SUTHERLAND SHIRE COUNCIL ASSESSMENT REPORT

Panel Reference	PPSSSH-103
DA Number	DA21/1251
LGA	Sutherland Shire Council
Proposed Development	Demolition of existing structures and construction of a mixed use development (health service facility and residential units) with Torrens title and stratum subdivision
Street Address	8-20 Hinkler Road, Caringbah and 319-333 Taren Point Road, Caringbah
Applicant/Owner	Hinkler Avenue No 1 Pty Ltd
Date of DA lodgement	13 December 2021
Number of Submissions	11 submissions were received on first notification. On renotification 4 unique submissions were received, although there were three which copied another submission or repeated from the earlier notification. A total of 15 unique submissions was received.
Recommendation	Refusal
Regional Development Criteria (Schedule 7 of the SEPP (State and Regional Development) 2011	The proposed development has a capital investment value of more than \$30 million, estimated at \$78,168,000.00.

Figure 7: 10am Extract from DA422 D

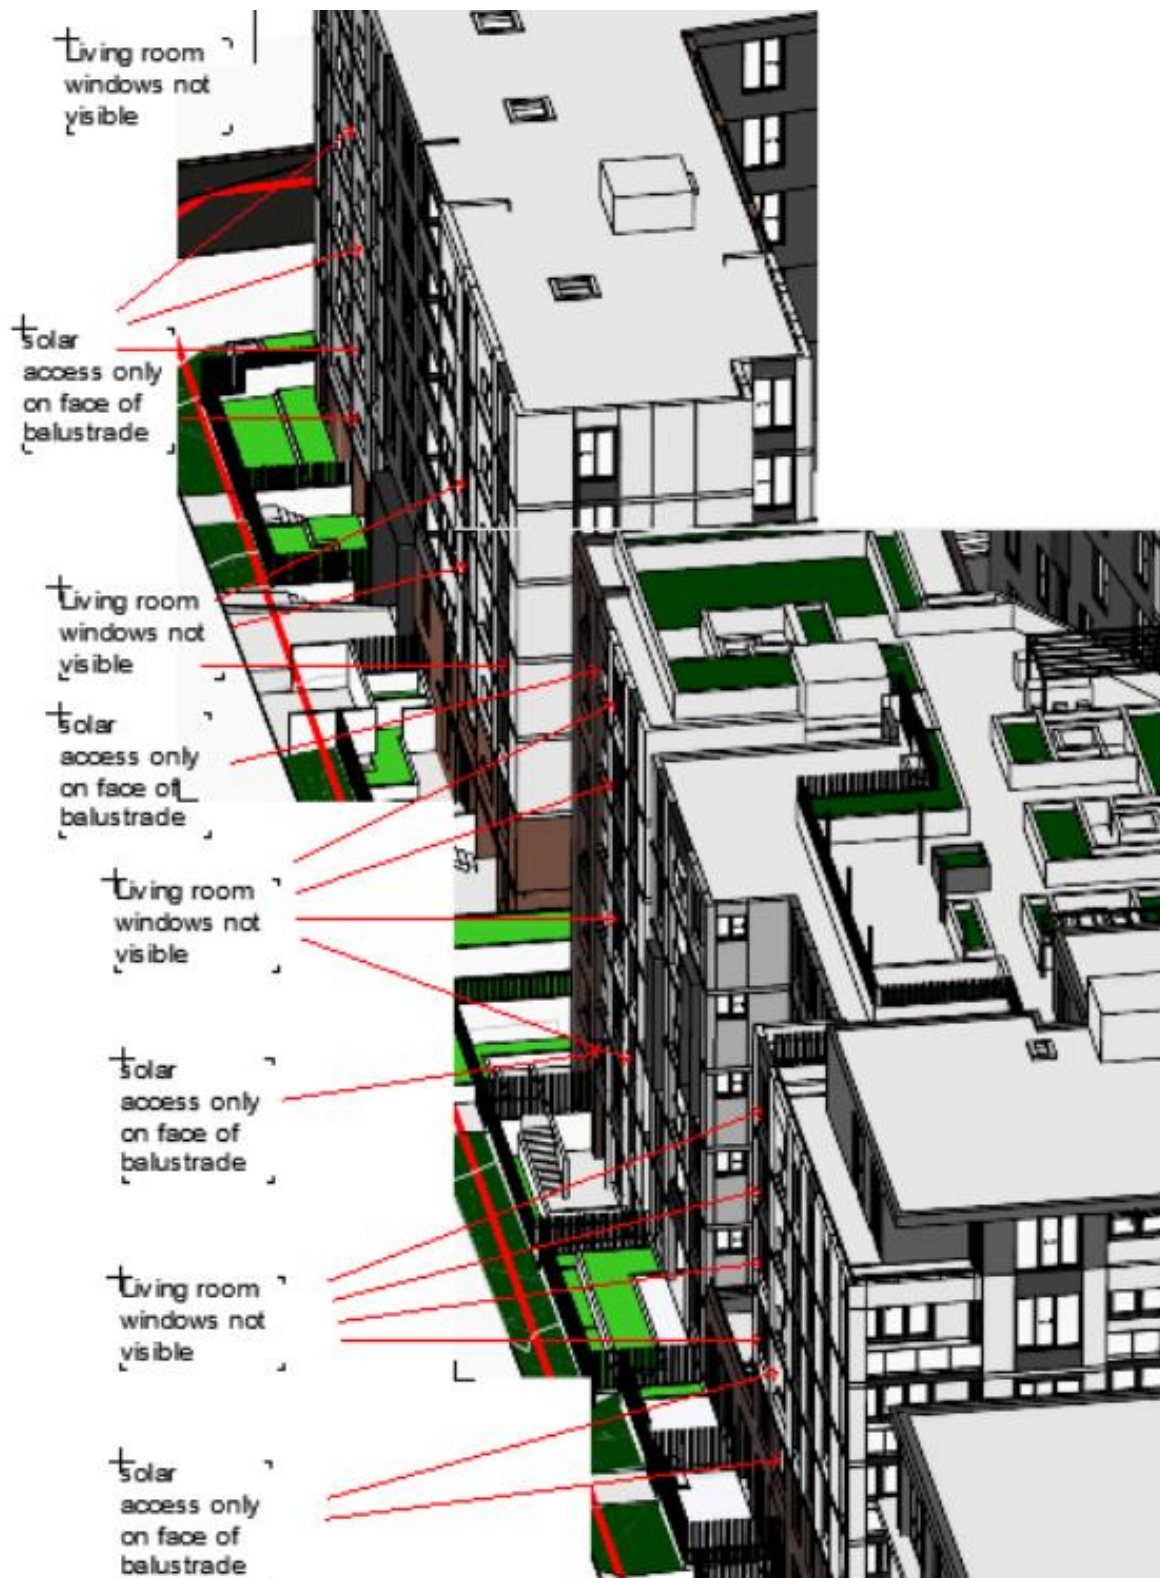
For east facing units claiming 2 hours of solar access between 8am and 4pm they must receive solar access to living rooms and private open space between 8am and 10am. However, the living room windows and balconies of the majority of these units are not visible on sun's eye view diagrams at 10am (See **Figure 7** below).

Figure 8: Discrepancy in shadow diagrams and suns eye view

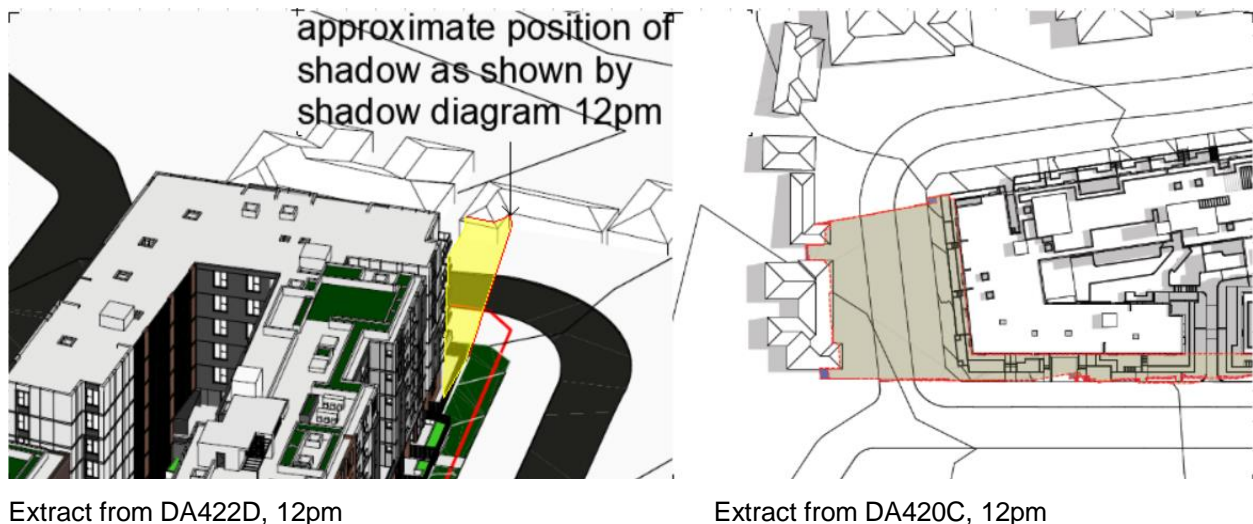
The position of shadows is not consistently depicted between suns eye view diagrams and shadow diagrams. The drawing extracts below (**Figure 8**) highlight the discrepancy between shadow diagrams and suns eye view diagrams. This issue should be clarified to allow the impact upon the neighbours to the south to be accurately determined. This is particularly important given that the proposed non-compliant height appears to be contributing to the loss of solar access to the southern neighbour. The impact upon the southern neighbour should be quantified (extent of solar access now available to the neighbour between 9am and 3pm) and the proposal refined to minimise loss of solar access to the neighbour.

Figure 10: East elevation of Building A (DA301 Rev D)

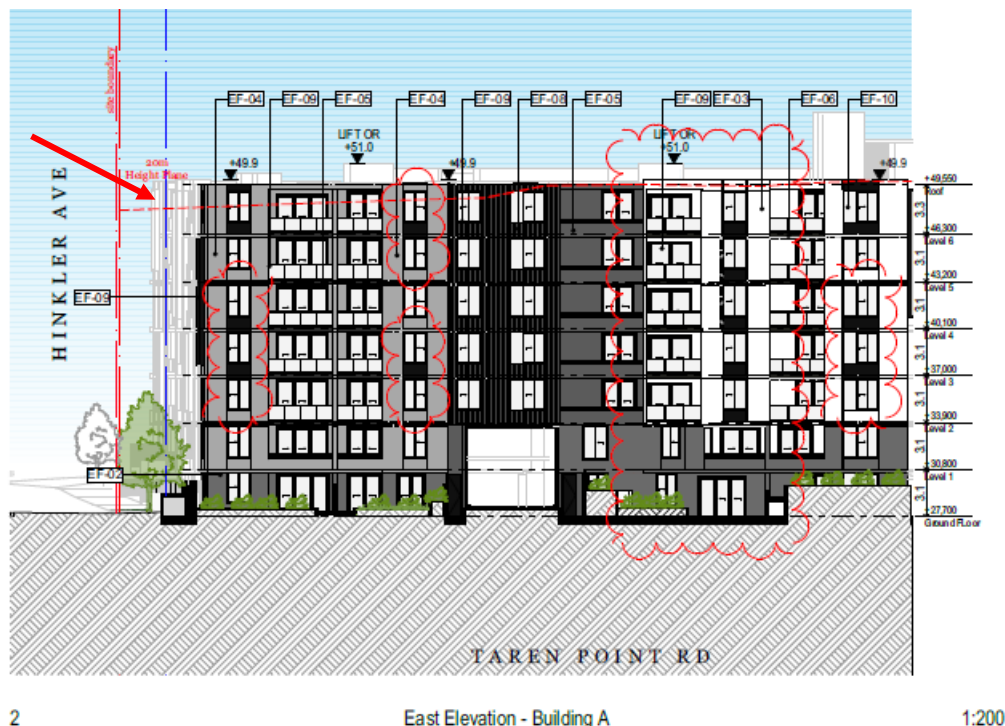
Figures 10 and 11 demonstrate the extent to which the height exceedances are encroaching into habitable space.

Figure 13: 12.00pm Extract from DA422 Rev D (24/11/22)

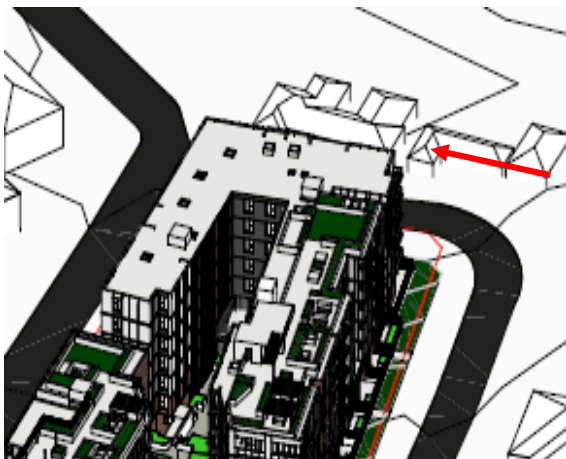
There remains a discrepancy between the shadow diagrams and the view from the sun diagrams as illustrated below. The shadow diagram shows shadows extending to 31 Hinkler Avenue to the south, however the view from the sun diagram does not show any shadowing to the same site (refer **Figures 13** and **14** below).
